Subject: Minutes of the February 15, 2008 MAGNASTOR Draft RAI Teleconference
Docket No. 72-1031 (TAC No. L23764)

Attachment 1 – MAGNASTOR Draft RAIs, NRC Conference Call February 15, 2008

MAGNASTOR Draft RAIs
NRC Conference Call February 15, 2008

Figure 3.8.3-1 Overall Model Plot for a Typical PWR Fuel Assembly

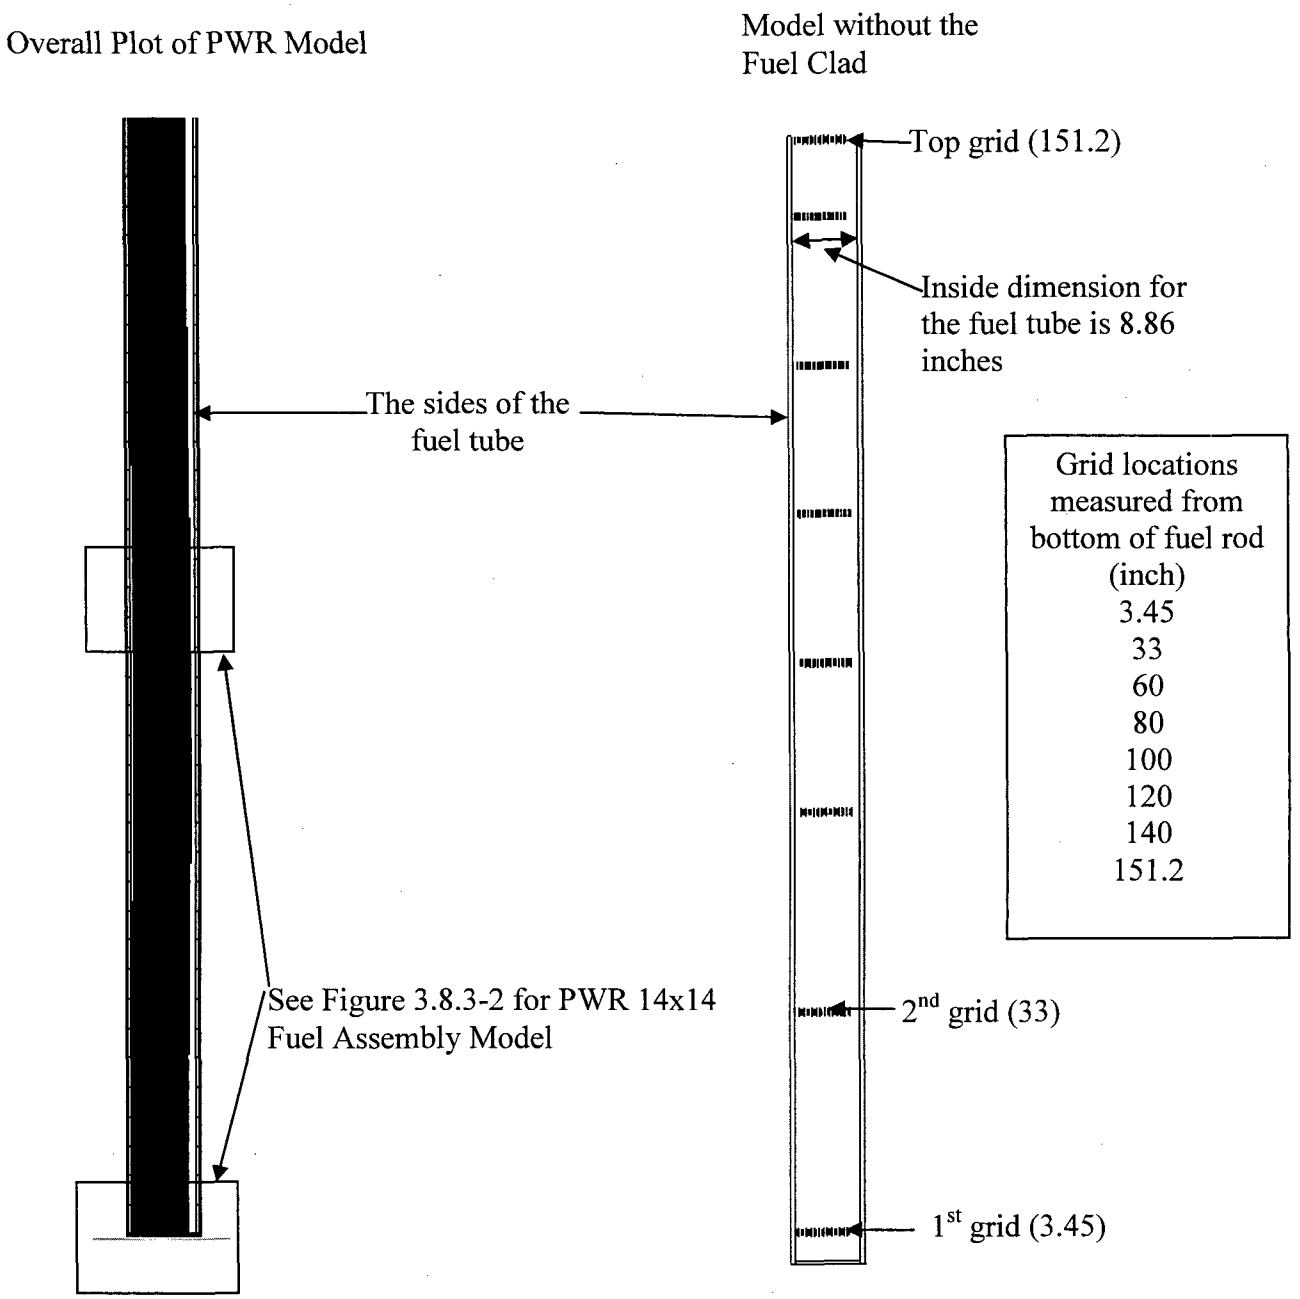
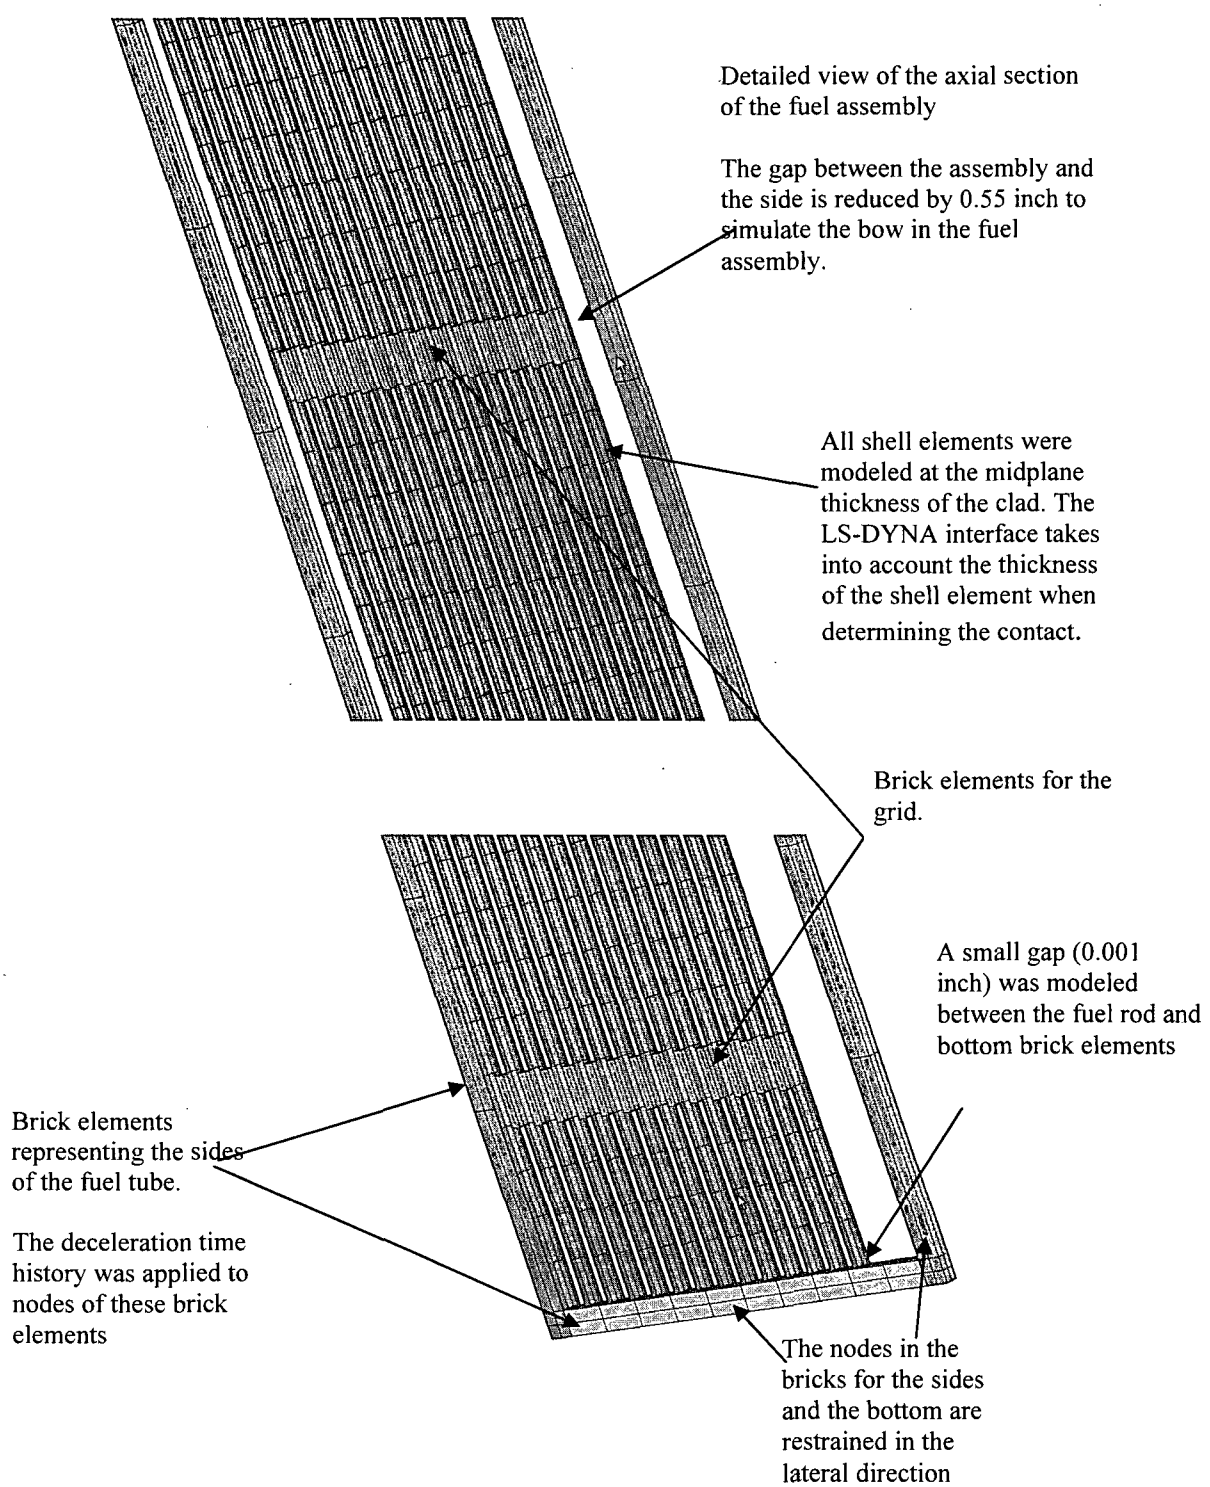
Revise Section 3.8 of the SAR fuel rod structural analysis for the 24-inch handling height concrete cask vertical drop accident. Add a fuel rod structural integrity evaluation for the side-drop impact associated with the concrete cask tip-over accident.

The applicant has previously submitted a proprietary report on fuel clad structural integrity for both the 24-inch handling height drop and non-mechanistic tip-over accidents. Relevant details should be summarized and presented in the SAR for the staff to make safety findings. Demonstration of fuel rod structural integrity is needed in the SAR to document that the spent fuel is in a sub-critical condition under credible conditions. The staff requires this description in the SAR to clearly document the methodology and results of the evaluation that is being approved for cask certification. This information is needed to demonstrate compliance with 10 CFR 72.236(c).

NAC agrees to provide a description of the analyses of the 24-inch end drop and tip-over/side drop configuration in Section 3.8 of the SAR to summarize the analytical model and analysis results previously provided to the NRC as NAC Calculation 71160-2026, Rev 0.

Section 3.8.1 will be replaced by the following presentation:

RIG SET MODULAR AIR BEARING SYSTEMS

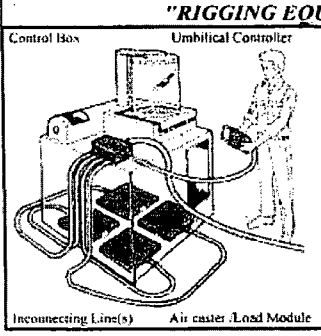
Clarify the description of Air Pad Rig Set provided on Table 9.1-1 of the SAR. Currently the SAR states the following description: "A device...air supplied at a high volume". The description should be modified as follows: "A device...air supplied at a high pressure." This information is needed to assure compliance with 10 CFR 72.11 and 72.236(f).

NAC agreed to provide supplemental air bearing equipment information. Technical data chart information defines system air pressure as 64 psi and air consumption at 435 scfm. Information on the air bearing equipment is provided on the following figure as copied from the referenced website.

Figure 1-A-1 BWR Partial Length Fuel Rod Location Sketches

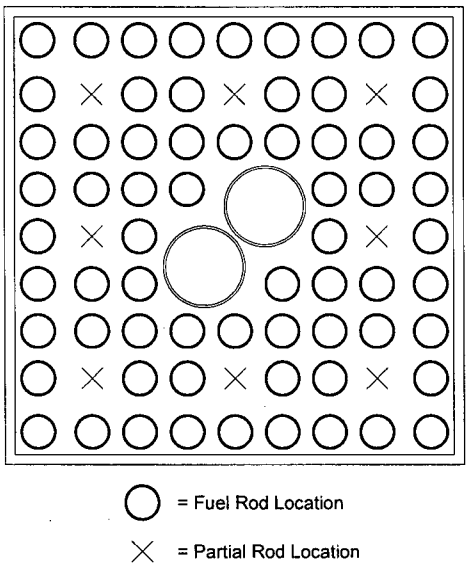
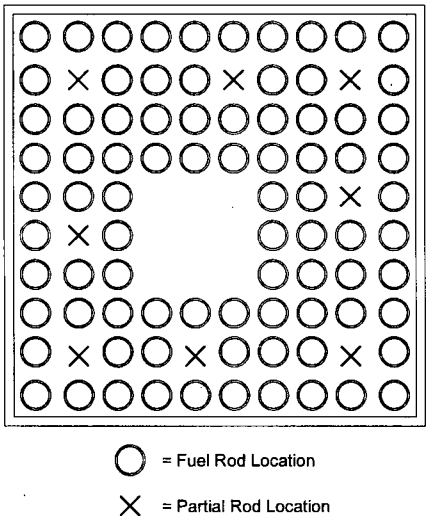
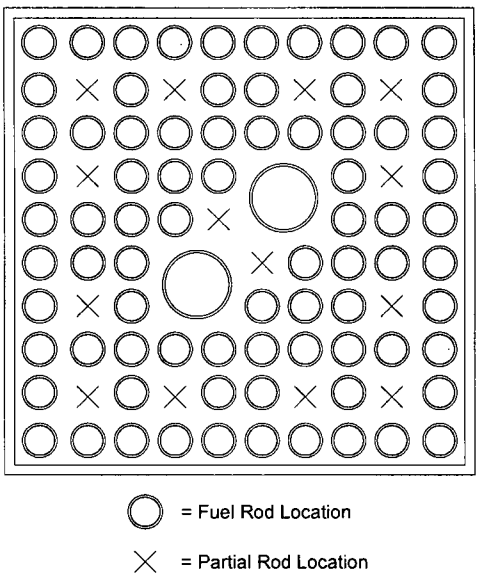
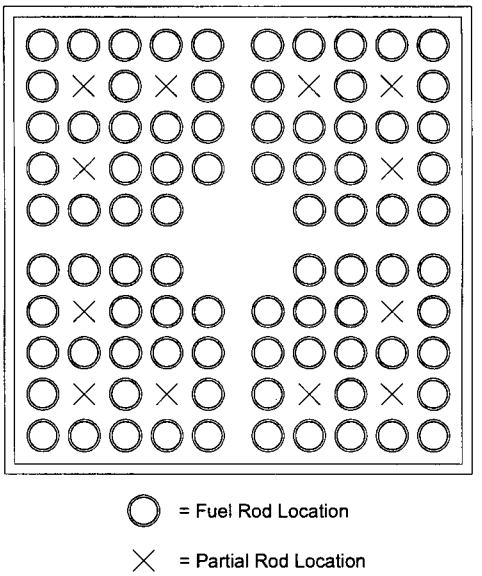
Change footnote a of Table 2-10 in Appendix B of the proposed Technical Specifications to read: Location of the partial length rods is illustrated in Figure 6.2.1-1 of the FSAR (Rev. 1, July 2007).

The current footnote reference does not match the actual figure depicting the locations of the partial-length rods for the applicable assemblies. Furthermore, the reference needs to indicate the appropriate revision of the drawing upon which the criticality analysis and the allowable contents specifications are based. This is necessary because any changes to the applicable assemblies with respect to the positioning of the partial-length rods constitute a change in the allowable contents specifications. This information is needed to confirm compliance with 72.236(a).

The specific revision of the figure was not included in the Technical Specification to allow 10 CFR 72.48 evaluations on modified partial rod locations. The presence of partial length rods has a minor effect on system reactivity but the specific location of the rods will not result in changes to the allowed enrichment. As NAC has not presented calculations for the possible variations GE may manufacture, NAC proposes to copy the figure into Section 1-A as Figure 1-A-1. This will allow for prior NRC approval per Section 2.1.2 of Appendix A.

"Location of the partial length rods is illustrated in ***Figure 1-A-1*** of the FSAR."

Table 1-A-2 covers the types of assemblies and their characteristics for the BWR 87-assembly and 82-assembly fuel baskets. ***Figure 1-A-1 locates the partial length rods within the BWR lattice.***
